RE: Lightning Electric Warehouse Construction Site

AFIN: 72-01867

NPDES Permit No.: ARR152624

NPDES Compliance Inspection Report

Photo #	5	Of	8		Date:	10/07/08	Time:	0905	
----------------	---	-----------	---	--	--------------	----------	--------------	------	--

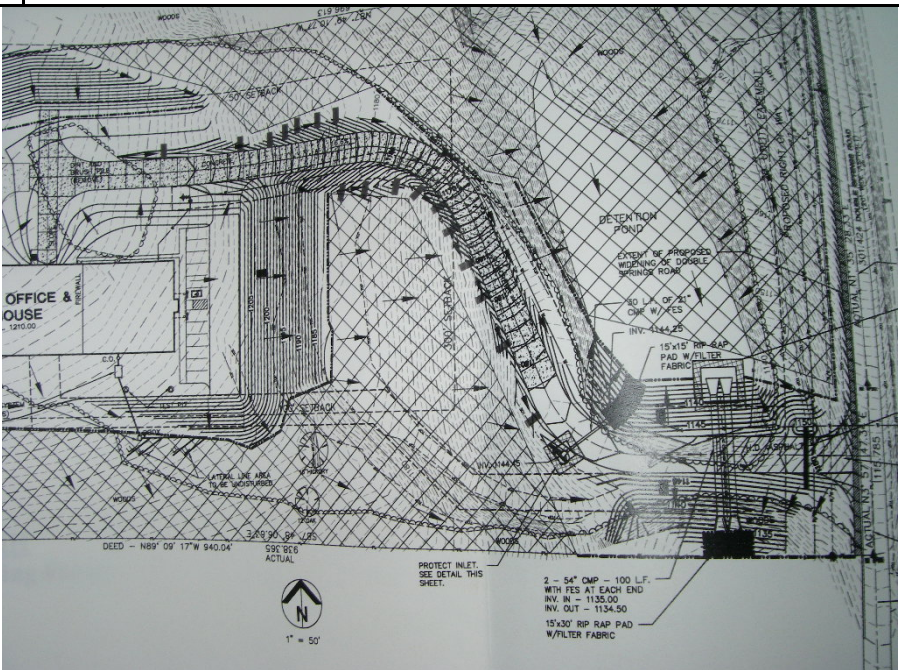
Description:	Sediment visible beyond silt fence (outfall) in drainage offsite. Looking south from construction entrance. This is above impacted pond (next photo). According to SWPPP, riprap and filter fabric were to be used at outfall.								
---------------------	--	--	--	--	--	--	--	--	--
